SUNDRY NOTICES AND REPORTS ON WELLS (DO NOT USE THIS FORM FOR PROPOSALS TO DRILL OR DEEPEN OR PLUG BACK TO A DIFFERENT RESERVIOR. USE "APPLICATION FOR PERMIT" (FORM C-101) FOR SUCH PROPOSALS.)		WELL API NO. <b>30-015-40138</b>

2. Name of Operator <b>Apache Corporation</b>		6. State Oil & Gas Lease No. <b>X0-0647-0405</b>
3. Address of Operator <b>303 Veterans Airpark Lane, Ste. 3000, Midland, TX 79705</b>		7. Lease Name or Unit Agreement Name <b>D State (308712)</b>

LEASE NAME	D State (308712)
WELL #	99
API #	30-015-40138
COUNTY	Eddy

PROPOSED PROCEDURE

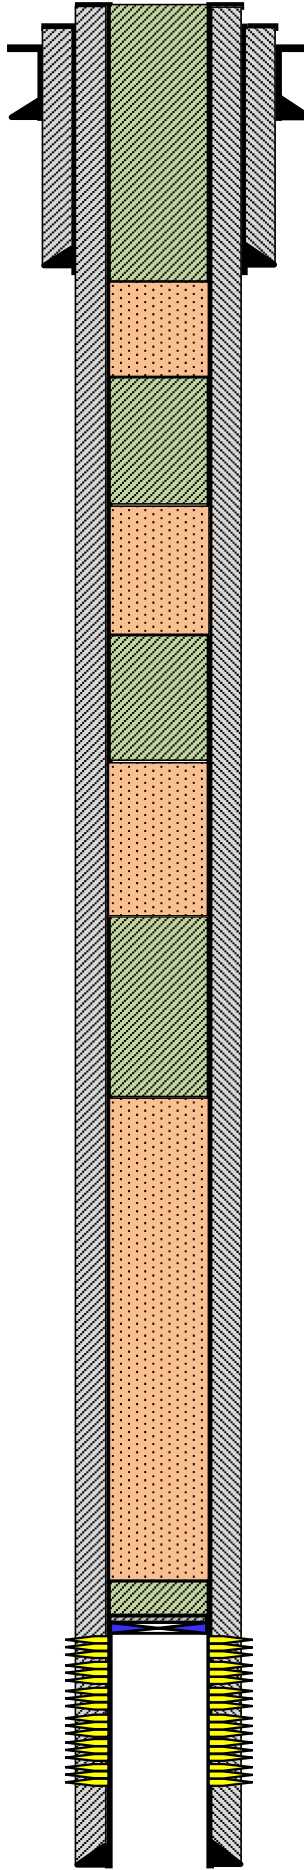
**SEE CHANGES TO PROCEDURE**

3. PUH & spot 35 sx Class "C" cmt from 1782'-1436',  
(Queen & Yeso) **WOC & Tag**

**WOC & Tag**  
1. MIRU P&A rig. RIH w/ tbg, CIRC w/MLF & spot 25  
Class "C" cmt from 4090'-3890' (Glorieta)
